# NOTICE OF DECISION

**CLASS 3 SITE PLAN REVIEW / CLASS 2 ADJUSTMENT / CLASS 2 DRIVEWAY APPROACH PERMIT / CLASS 1 DESIGN REVIEW CASE NO.: SPR-ADJ-DAP-DR22-10**

**SUMMARY:** Proposed development of a new five story multi-family apartment building containing 157 dwelling units.

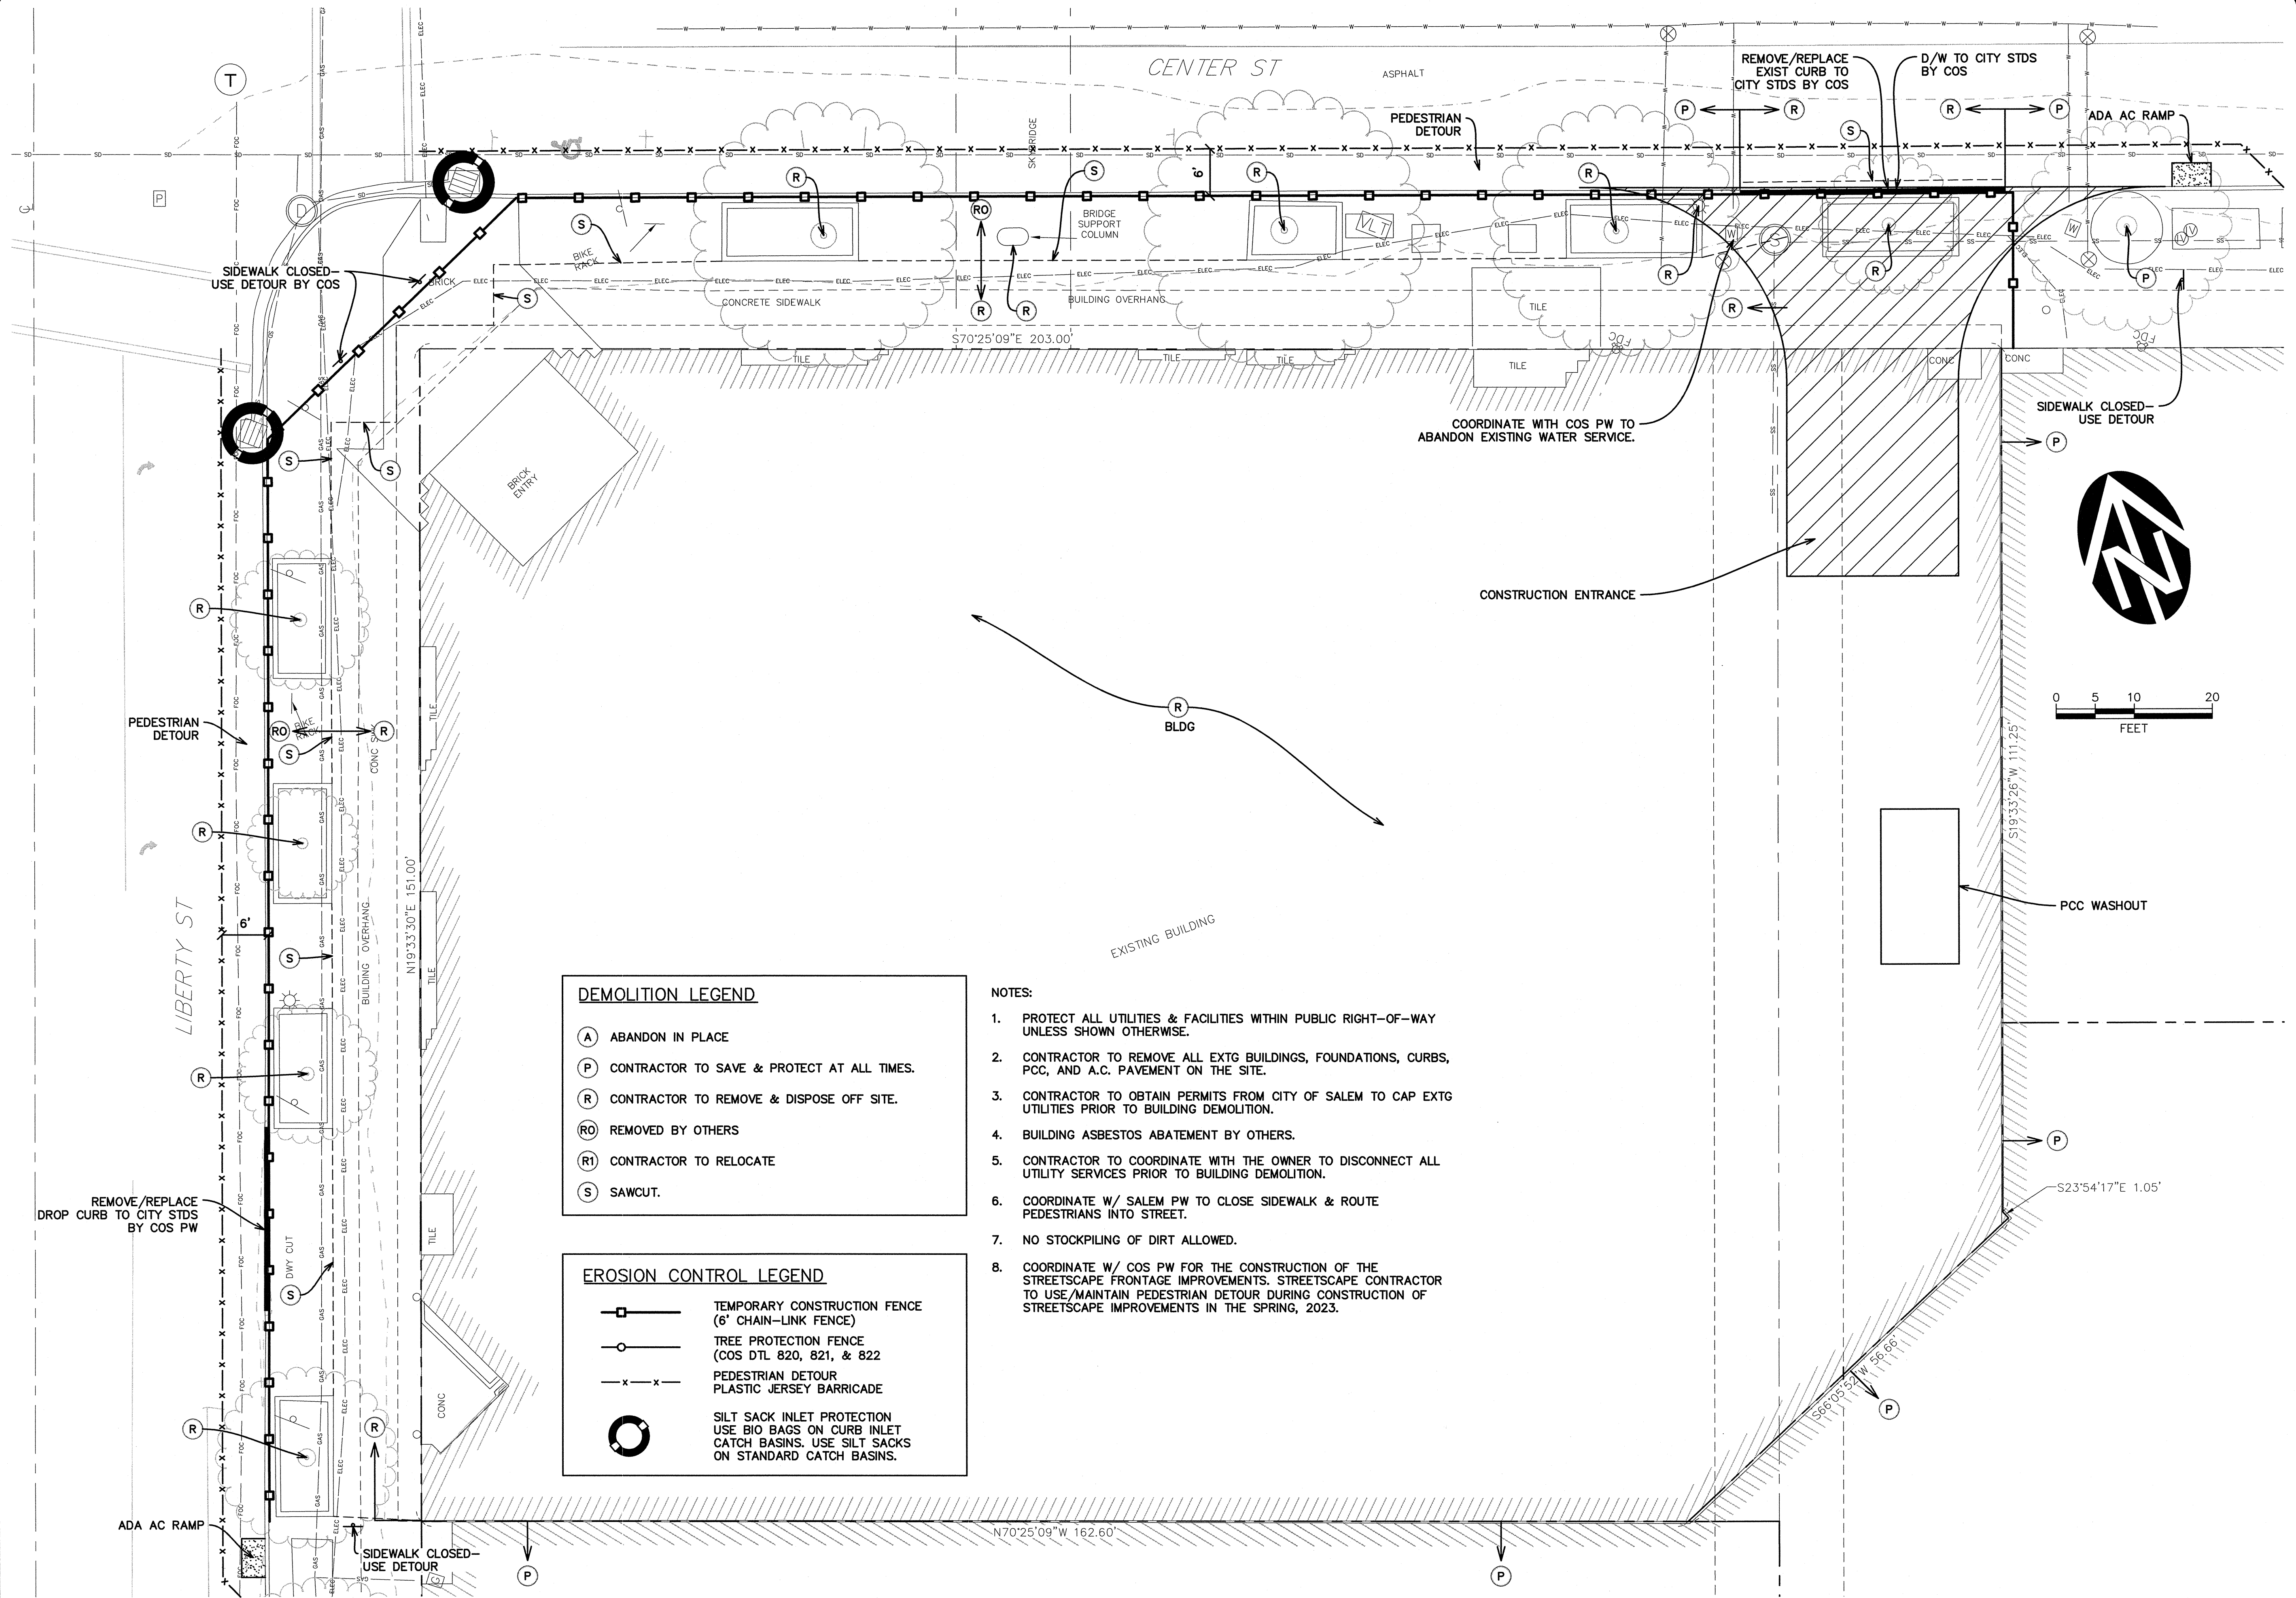
The Fire Department has reviewed the proposal and indicated that on Sheet A1.01 #10: Coil Grill Rollup Door requires fire department access (both north and south doors). Opti-com or key box/key switch. On Sheet C3.0: A post Indicator Valve will be required next to FDC if external access to the Fire Sprinkler Riser Room is not provided. Fire Department comments will be verified at the time of building permit submittal.
